Ann Arbor Historic District Commission Staff Report

Address: 332 E William St.

Application Number: HDC26-0043.

Application: The applicant seeks HDC approval to pave a driveway and rear parking area with concrete.

ALTA/NSPS LAND TITLE SURVEY OF A PARCEL OF LAND LOCATED IN THE SE 1/4 OF SECTION 29, T2S, R6E, CITY OF ANN ARBOR, WASHTENAW COUNTY, MICHIGAN

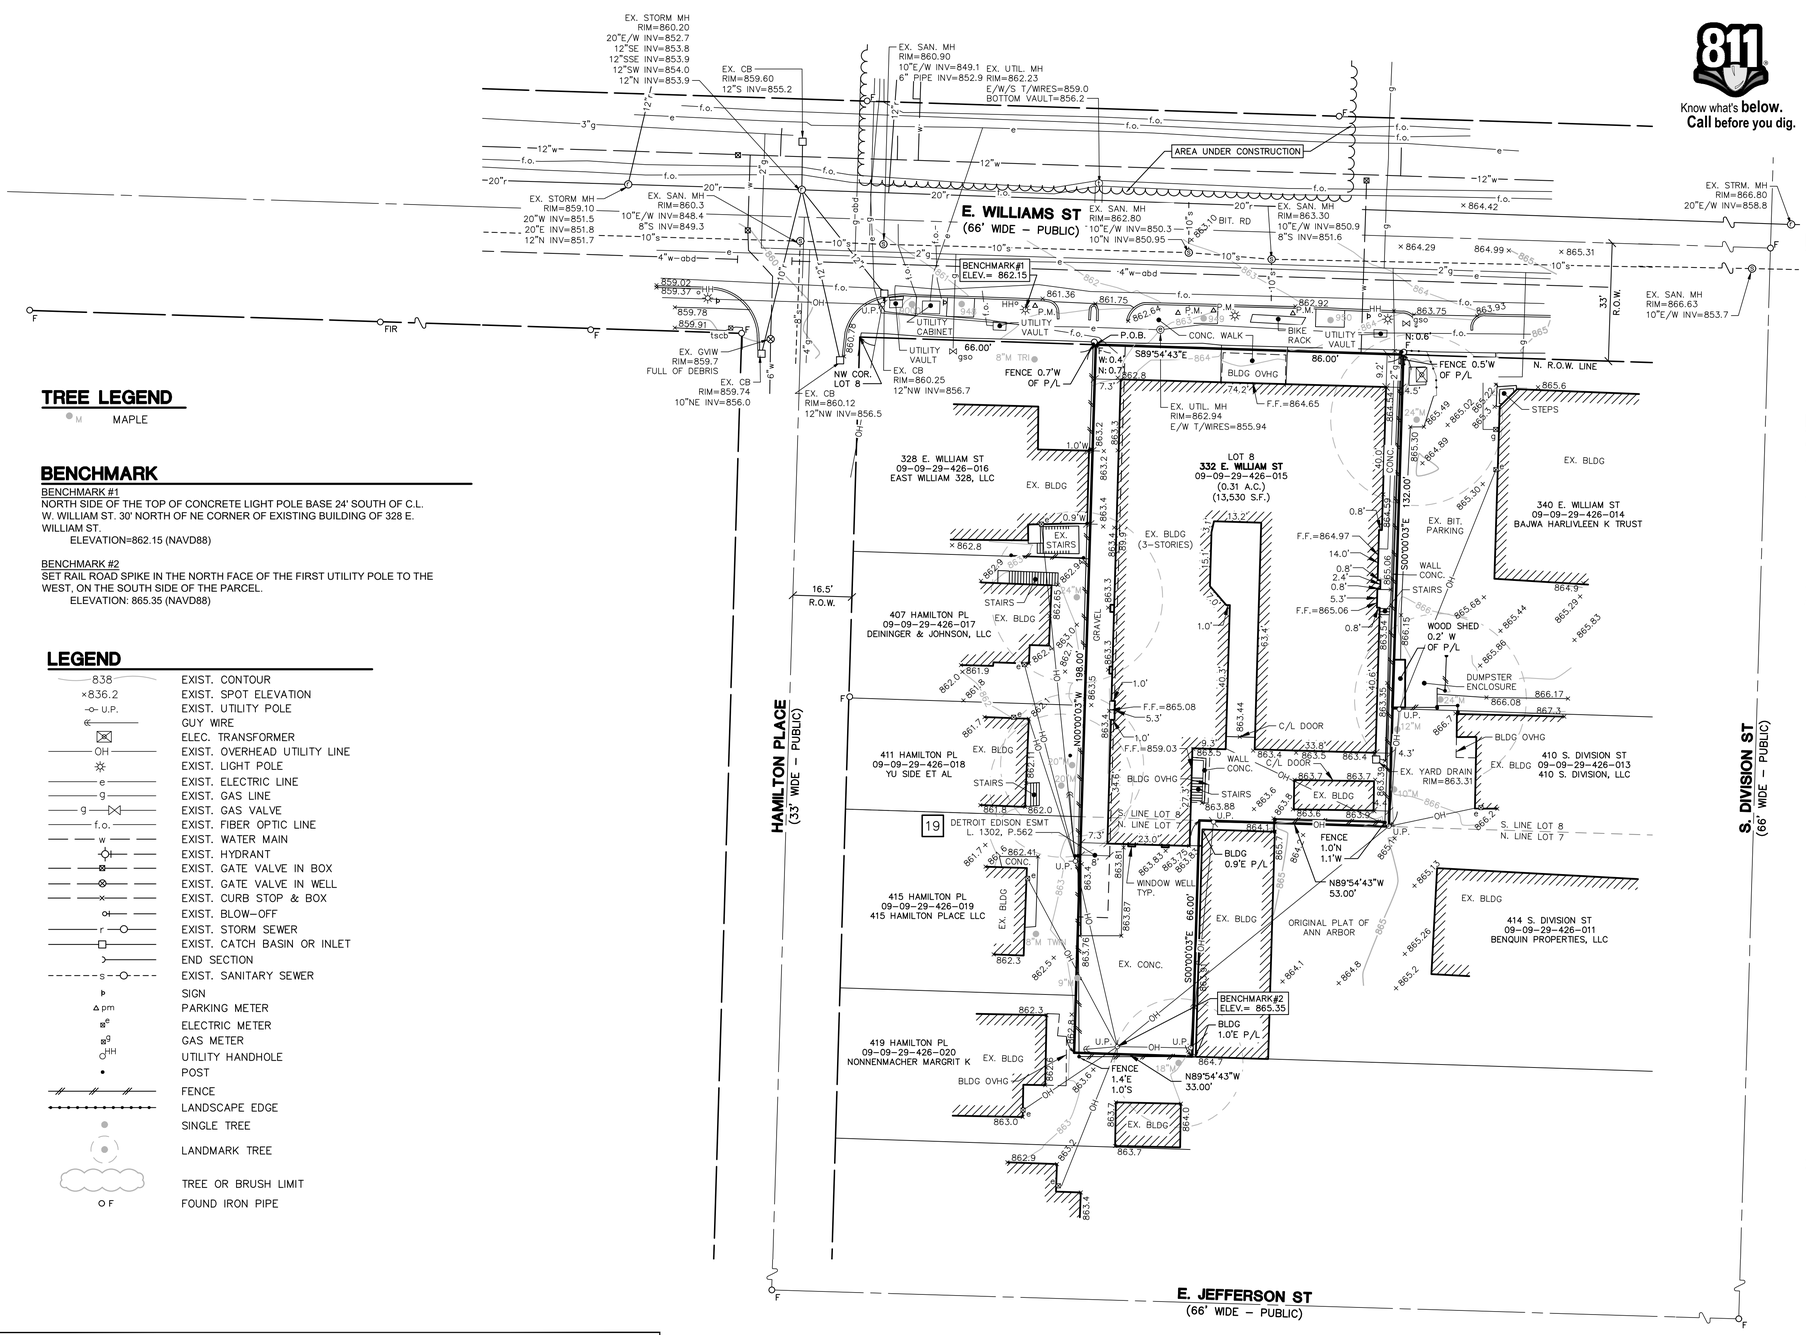
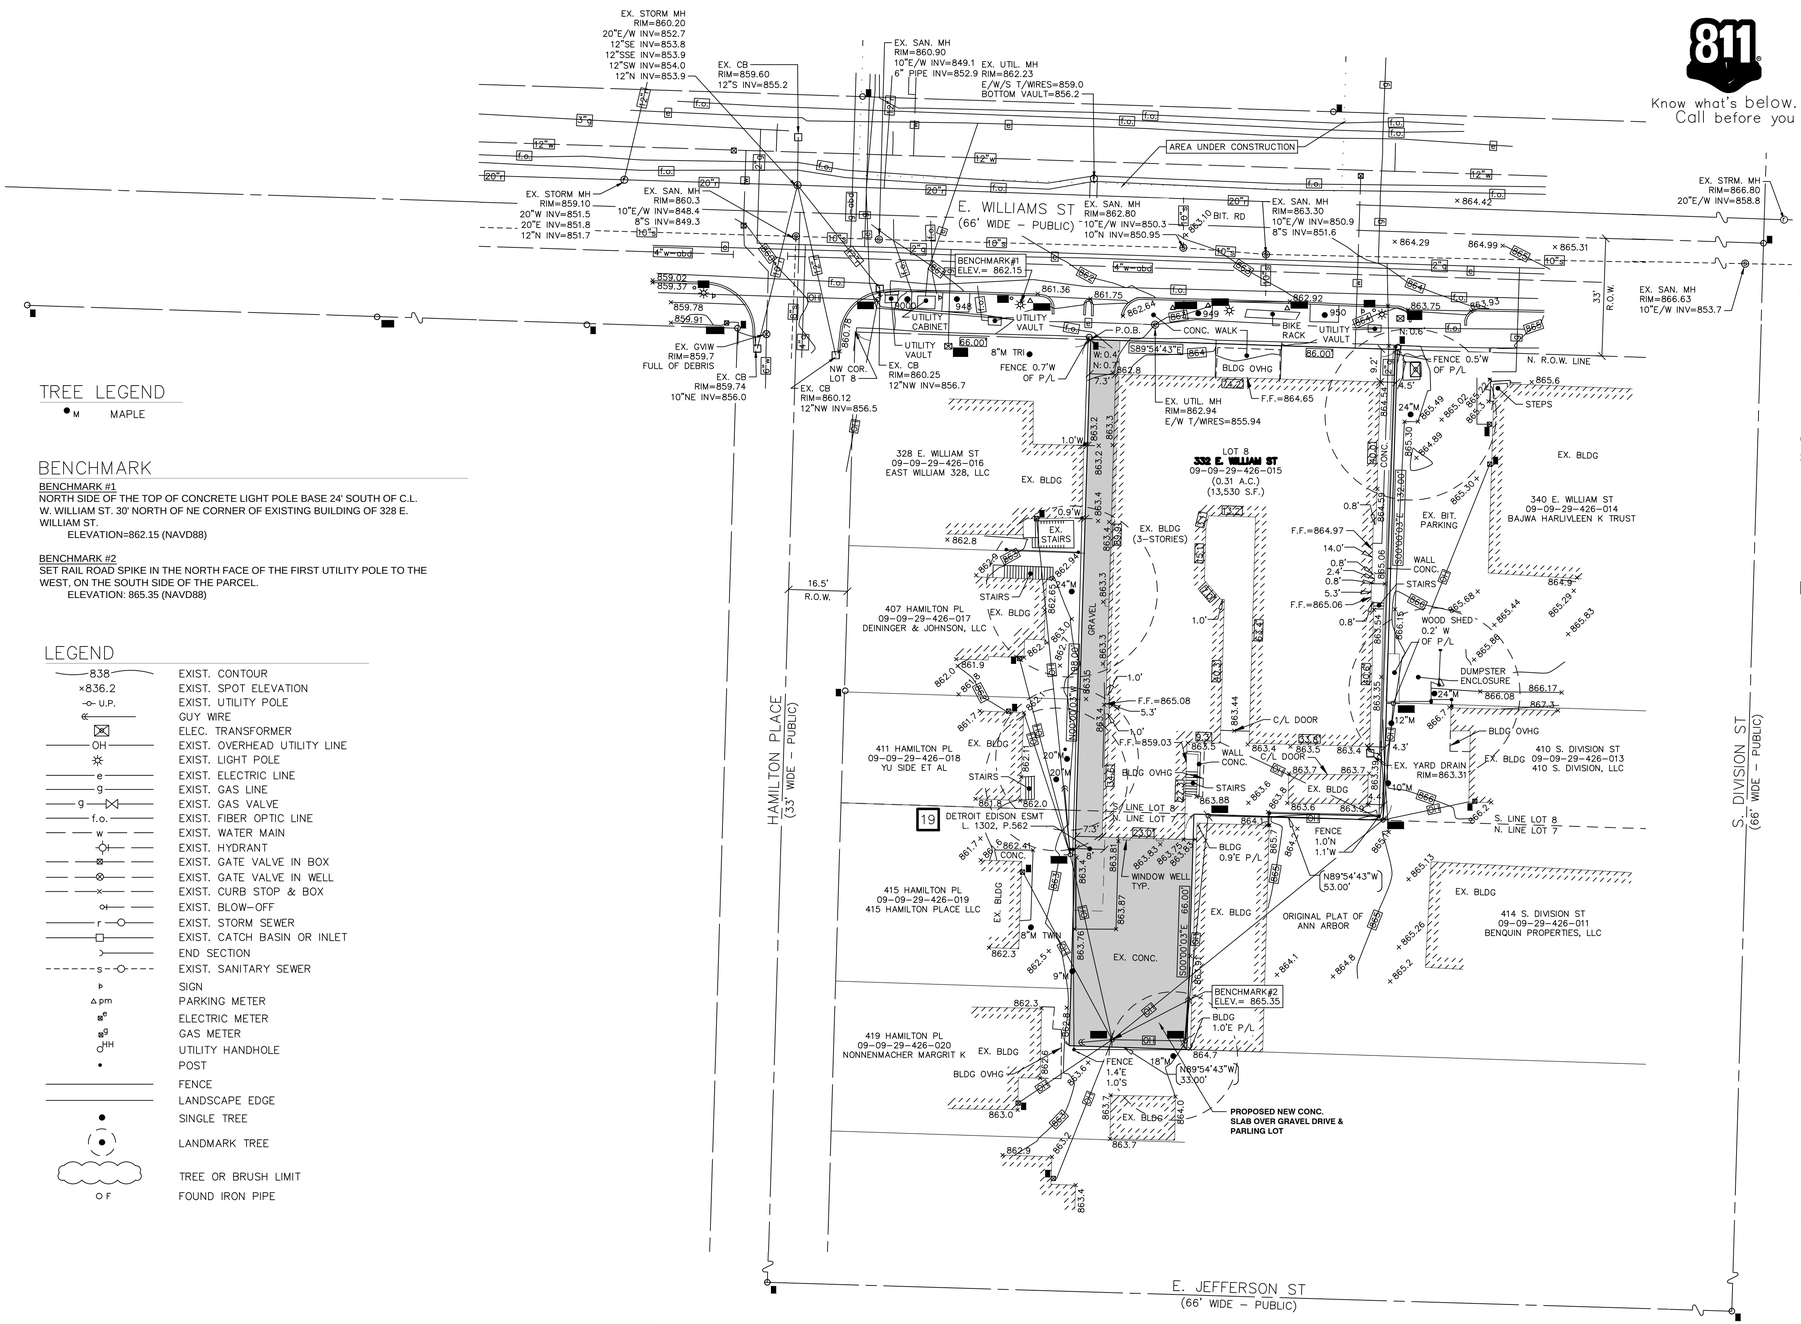
1. The work was started without permits or a Certificate of Appropriateness and the parking area is around 70% paved. The driveway and remainder of the parking area are packed dirt and gravel. If approved by the HDC the work will require a site plan approved by the City Planning Commission.

2. The driveway is 7.3 feet wide and runs along the west side of the building. The parking area is 33 feet by 66 feet. Aerial photos show no more than five or possibly six cars in the parking area. There are no trees or natural features on the property in the area to be paved. No trees were removed for the paving that has already occurred.

3. After the Review Committee site visit, staff will report back on how the paving interacts where it meets the building, including around existing window wells.

4. Paving the driveway and parking area should not negatively affect the historic structure or surrounding neighborhood. Staff recommends approval.
